Access Compliance Report Public Rights-of-Way (Curb Ramps)

Main Street: **BRENAN_WAY** Cross Street: **BEACHMONT_AVE** Location: **E**

ADA ID: **RPRK220125125012** Ramp Type: **Type 4 - Parallel** Initial Pass/Fail: **Fail** Overall Compliance: **No** Severity Score: **2**

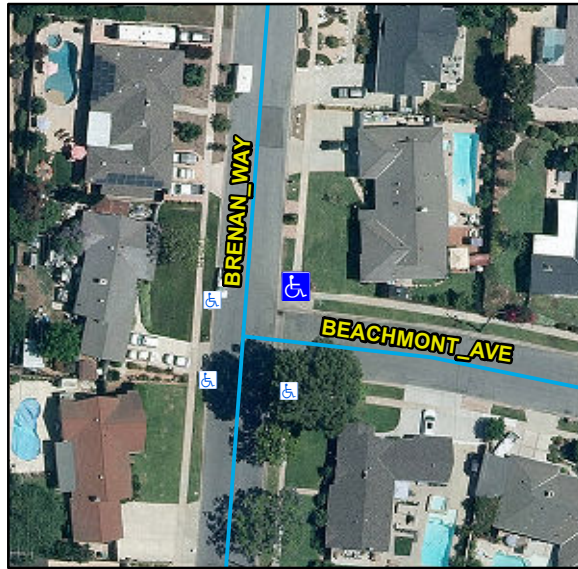
Remove & Replace Curb Ramp With Two New Directional Ramps or Equivalent.

Compliance	Description	Data	Compliance	Description	Data
N/A	Ramp Length LT (in)	148	N/A	Ramp Length RT (in)	129
Yes	Ramp Width LT (in)	101	Yes	Ramp Width RT (in)	101
Yes	Ramp Run Slope LT (%)	6.4	Yes	Ramp Run Slope RT (%)	6.6
No	Ramp Cross Slope LT (%)	2.8	No	Ramp Cross Slope RT (%)	3.2
N/A	Landing Present	N/A	N/A	DWS Provided	N/A
N/A	Landing Length (in)	N/A	N/A	DWS Contrast	N/A
N/A	Landing Width (in)	N/A	N/A	DWS Length (in)	N/A
N/A	Landing Run Slope (%)	N/A	N/A	DWS Full Width	N/A
N/A	Landing Cross Slope (%)	N/A		DWS Offset Type	N/A
N/A	Landing Movement Obstructed?	N/A	N/A	DWS Offset Left (in)	N/A
	Landing Movement Type	N/A	N/A	DWS Offset Right (in)	N/A
N/A	Landing Shared	N/A			
N/A	Clear Space	Yes			
N/A	Clear Space To Crosswalk (in)	N/A			
N/A	Marked Crosswalk 1	No	N/A	Marked Crosswalk 2	No
	Crossing 1 Direction	NW		Crossing 2 Direction	SW
	Marked Crosswalk 1 Width (in)	N/A		Marked Crosswalk 2 Width (in)	N/A
